Application for Licence Amendment

Licence Number	L9012/2016/1
Licence Holder	Linden Gold Pty Ltd
ACN	138 222 705
File Number	DER2016/002205
Premises	Second Fortune Gold Mine Mining tenements M39/255, M39/649, M39/650 and miscellaneous licence L39/12 MENZIES WA 6436 (as defined by the Premises maps attached to the revised licence.
Date of Report	19 May 2022
Decision	Revised licence granted

Samara Rogers
A/MANAGER, RESOURCE INDUSTRIES
REGULATORY SERVICES

Figure 3: Existing and proposed groundwater monitoring bore locations

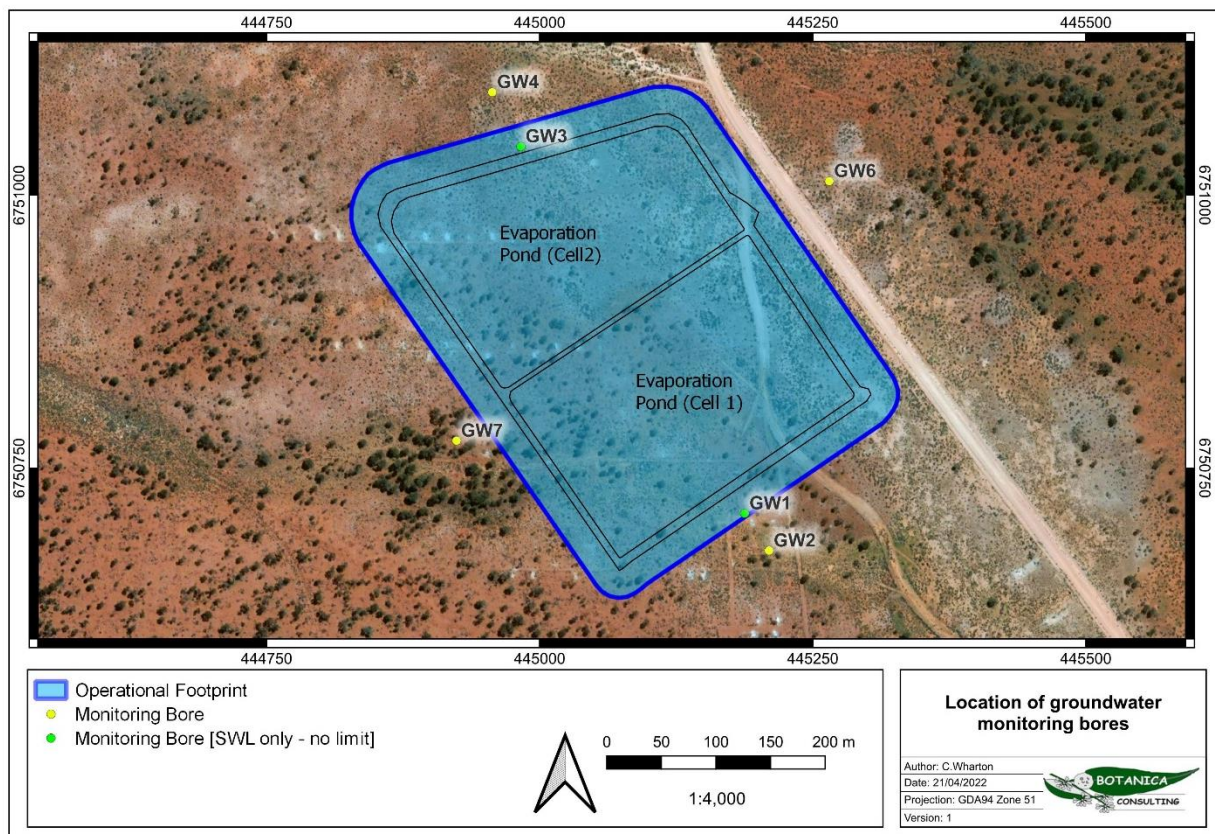
To address the increasing SWL at the evaporation ponds, the Licence Holder proposed to reduce the volume of mine dewater deposited into the evaporation ponds (refer to Section 2.2.2). In addition, the Licence Holder intends to establish a 25 m buffer one around the evaporation zone, such that SWL limits do not apply within the buffer zone, where monitoring bores GW1 and GW3 are located within.

In liaising with the department, the Licence Holder proposed replacing GW1 and GW3, with GW6 and GW7 at the eastern and western portion of the evaporation pond, outside the 25 m buffer zone, to improve the monitoring coverage of the bore network (Figure 3). The construction details of the two bores are not known, as its likely they were installed in 2017 or earlier to monitor and investigate historical groundwater mounding at the evaporation ponds.

It was noted that the depth of the six monitoring bores is not currently known. As such, it is difficult to obtain a better understanding of the natural, pre-seepage depth to groundwater at the evaporation ponds.

Conditions 22 and 23 relate to the investigation of the depth of existing monitoring bores around the evaporation ponds. The depths of these bores are currently not known to both the department and the Licence Holder. The data is relevant for assessing ambient groundwater levels once mounding of the water table has stabilised. Additionally, it will inform the ability of these bores to detect early signs of groundwater mounding in the future. If the bore depth is significantly shallower than the natural water table, then the occurrence of mounding would not be detectable by monitoring these bores until the water table have become significantly and sufficiently mounded to reach the bores. This scenario would not be conducive for early detection and management of seepage from the evaporation ponds.

Figure 6: Location of evaporation cannons and extent of spray drift during trial

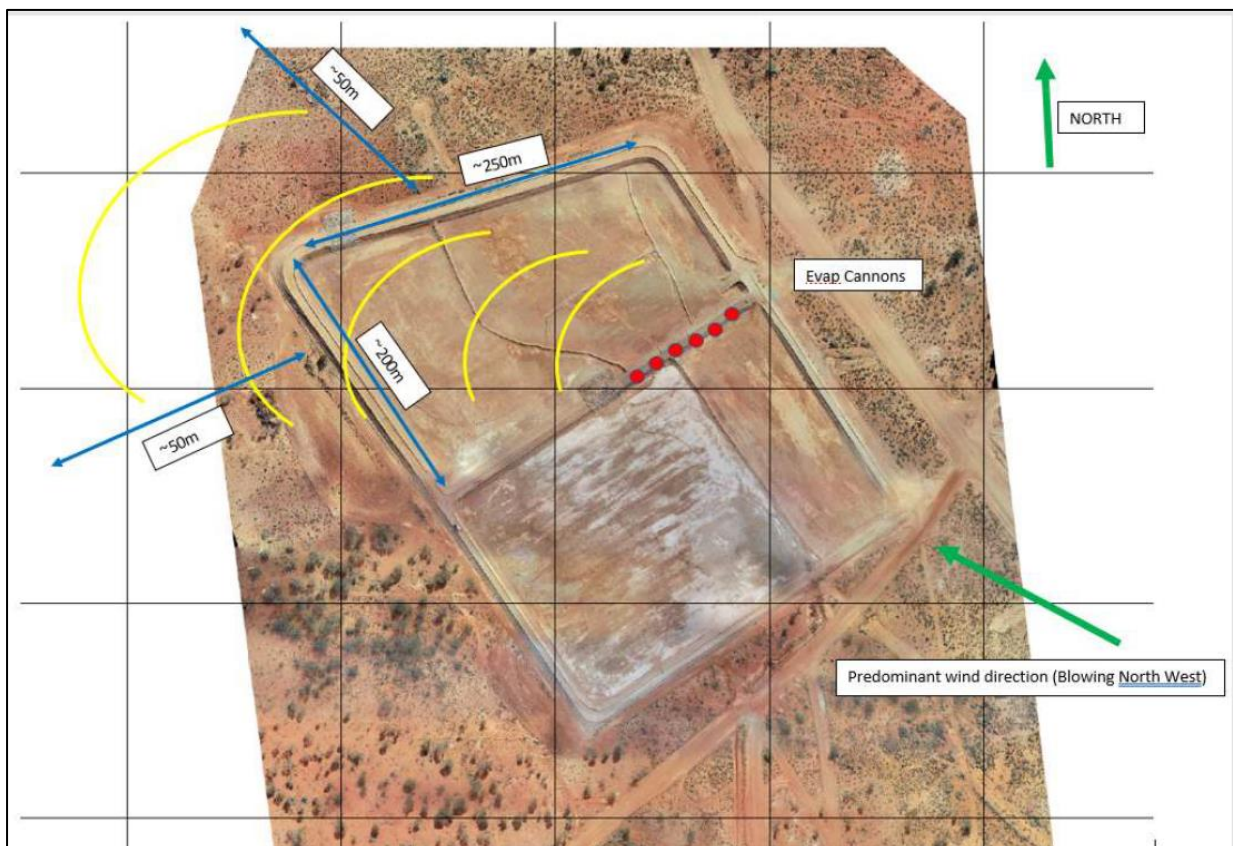
In a pilot trial conducted in early 2021, a series of six evaporation cannons were installed on the eastern side of the middle causeway, between evaporation ponds Cell 1 and Cell 2. The prevailing wind direction was noted to be from the southeast.

During operation, salt spray was observed on the adjacent native vegetation, indicating that spray drift of salt particulates had occurred. The extent of the salt spray was approximately 300 m from the cannons (i.e. discharge point) (Figure 6). The salt spray was described as very light and washed off after the first rainfall event.

Based on the outcomes of the trial, the Licence Holder proposed to install the evaporation cannons in the southeast corner of the evaporation ponds. By doing so, the cannons would be aligned in the correct wind path for optimal performance (i.e. achieve maximum evaporation rate), whilst ensuring the spray is always directed over the evaporation ponds to collect any potential salt residue in the fallout (Figure 7). It was thought that the operational footprint of the evaporation ponds would provide an adequate distance of approximately 300 m to 500 m to capture any spray drift.
